## **Proposal for a new supplement to Regulation No. 118**

### **“Fire resistance of interior materials”**

#### **Submitted by the experts from the European Association of Automotive Suppliers – CLEPA**

### Example 2

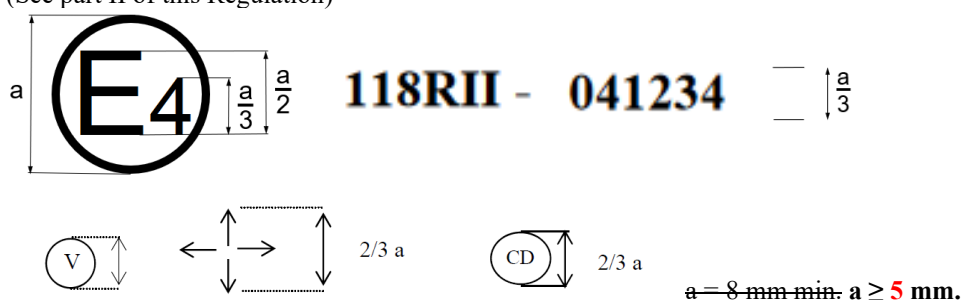
*Amend Example 2 of the arrangement of the approval mark in Annex 5, as follows:*

The above approval mark affixed to a component shows that the type concerned was approved in the Netherlands (E4) pursuant to Part II of UN Regulation No. 118 under approval number 041234. The first two digits (04) of the approval number indicate that the approval was granted in accordance with the requirements of the 04 series of amendments to UN Regulation No. 118.
